THE ILLINOIS STATE TOLL HIGHWAY AUTHORITY

DESIGN BULLETIN No. 20-04

SUBJECT: VWIM Base Sheets Updates

**WEIGH-IN-MOTION
SITE LAYOUT
6 LANES**

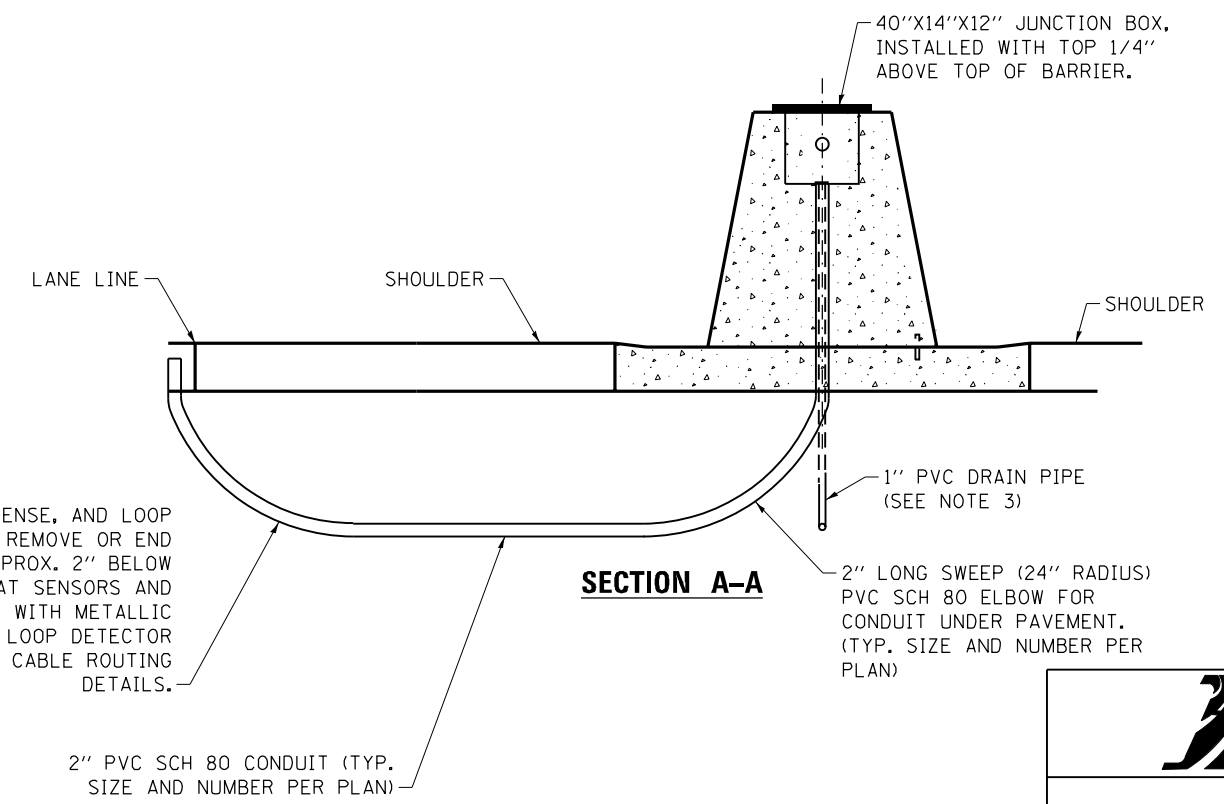
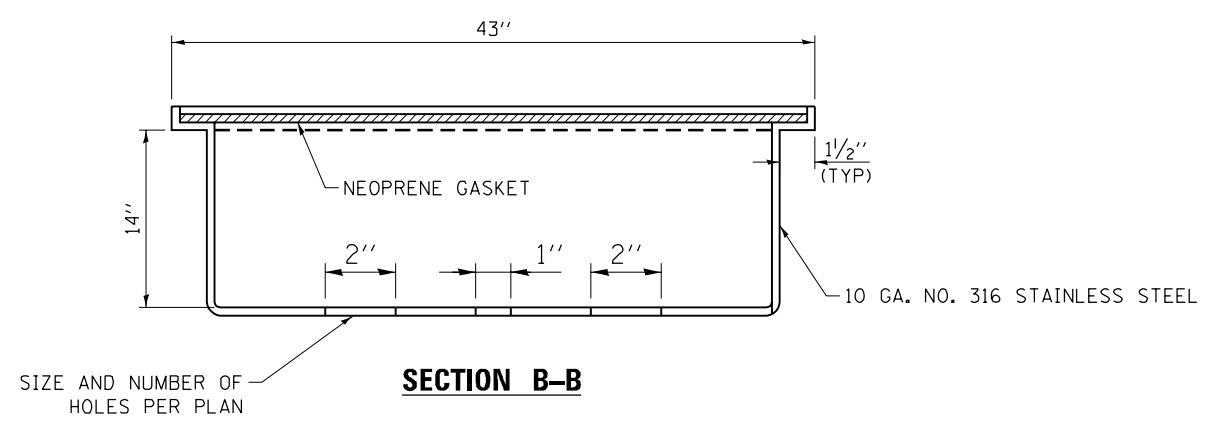
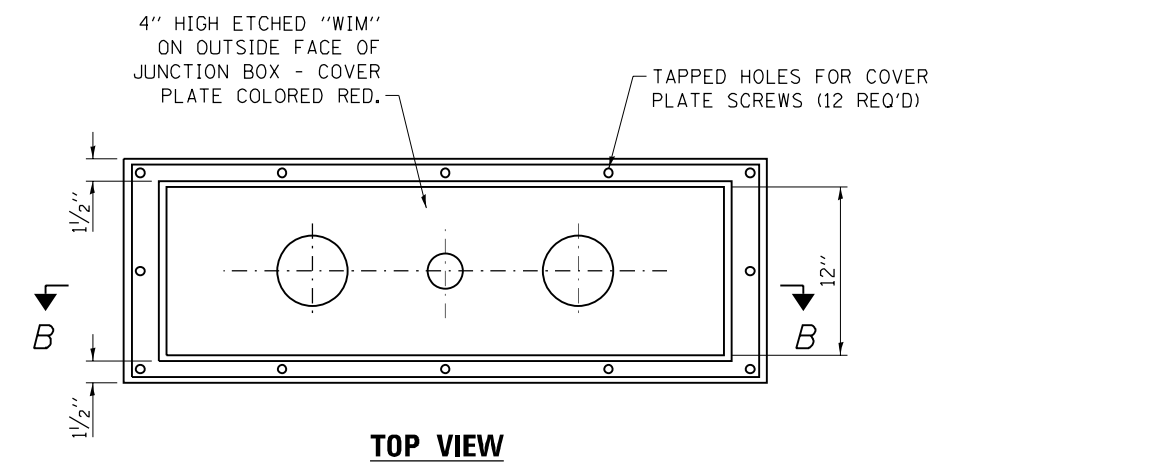
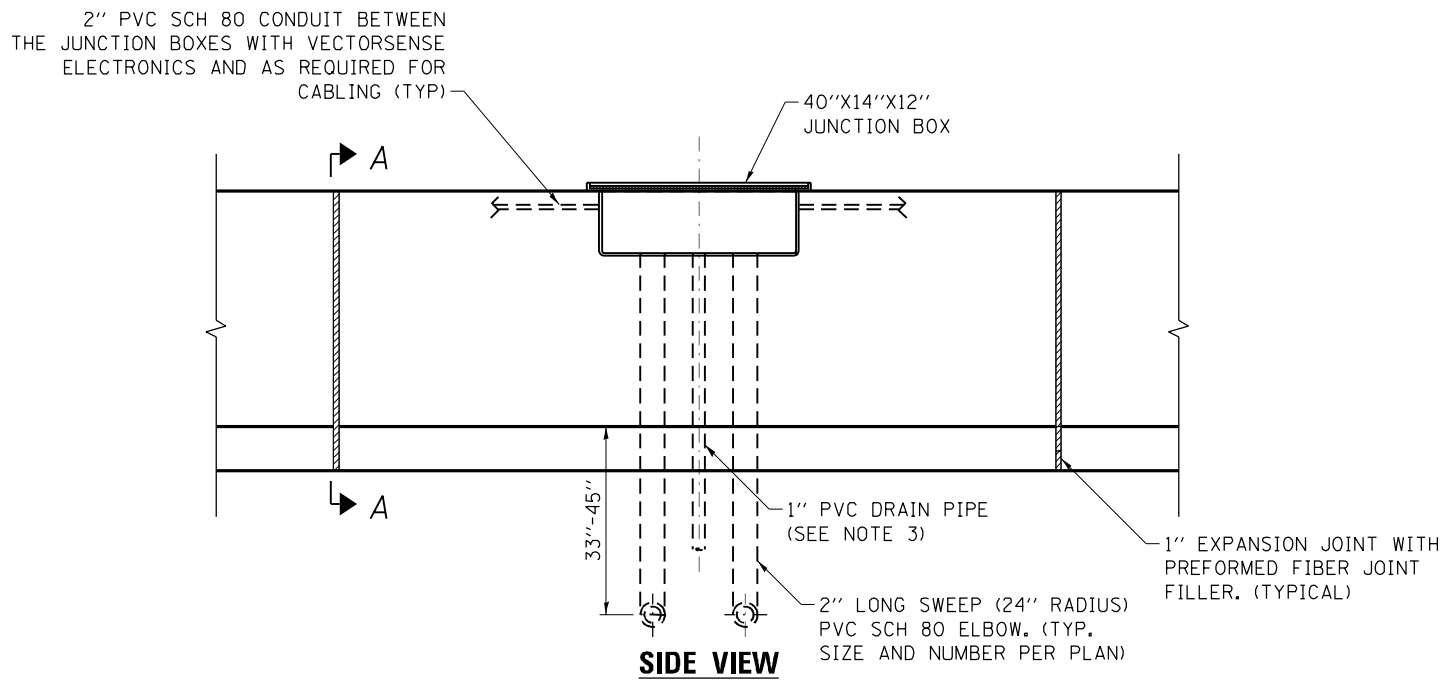
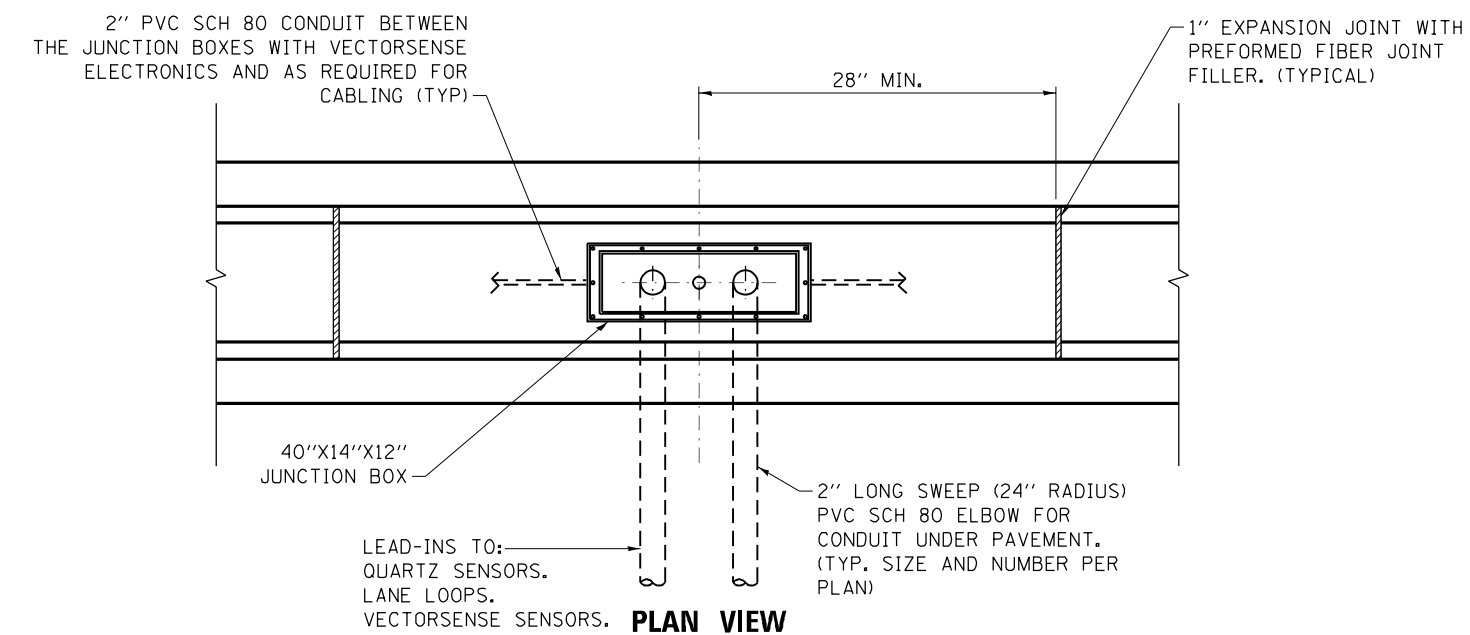
M-ITS-1605	Weigh-In-Motion Site Layout 6 Lanes (3 sheets)
	Complete revision to this sheet. Previous sheet was for detector housing. Created 3 sheets for site overview, wiring layout and site layout.
M-ITS-1606	Weigh-In-Motion Junction Box Detail
	Increased size of junction box to accommodate Vectorsense electronics box, revised conduits to match revised layouts and revised notes.
M-ITS-1607	Weigh-In-Motion Height Detector
	Added IP cameras and IR illuminators to poles, clarified pole types and detector height requirements, eliminated metric units, and revised conduit/handholes to match revised layouts.
M-ITS-1608	Weigh-In-Motion Quartz Sensor Details
	New sheet
M-ITS-1609	Weigh-In-Motion Vectorsense Sensor Details
	New sheet
